## Supplemental Information

This Document Errata reflects changes made on the datasheet for device 854S006I.

**January 27, 2010:** First version of documentation errata for this device. There is no change to the actual characteristics or design of the device. This is only a change to the datasheet to correct a datasheet error.

### BLOCK DIAGRAM

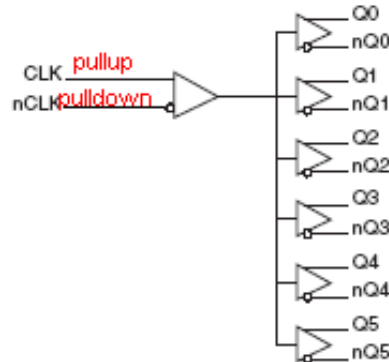
PAGE	DESCRIPTION OF CHANGE
Page 1	<b>Block Diagram.</b> Update Pullup and Pulldown of CLK and nCLK on the block diagram
